US Army Corps
Of Engineers
St. Paul District

MISSISSIPPI RIVER 9-FOOT CHANNEL PROJECT

DEFINITE PROJECT REPORT/ ENVIRONMENTAL ASSESSMENT

CHANNEL MANAGEMENT STUDY

Figure 1

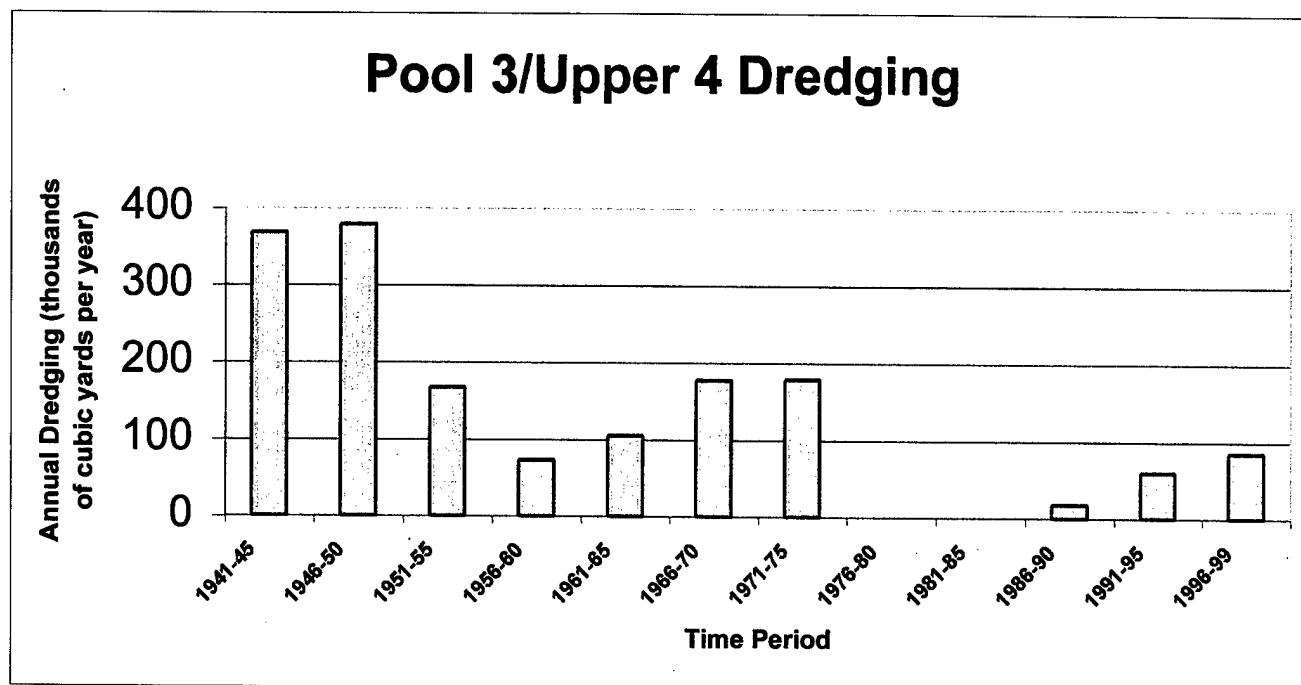
12 | Figure 1, page 5-4, should have an asterisk by the years 1996-98 with an explanation of the higher dredging quantities during those years. The quantities of material dredged in 1998 were higher than normal because the contractor cleaned out the channel during the process of unloading Corps Island. I believe 120,000 cubic yards was taken out of the channel in 1998 and even though minimal depth dredging was the normal during the last several years, this amount was in excess of what would typically be dredged to maintain the nine-foot channel.
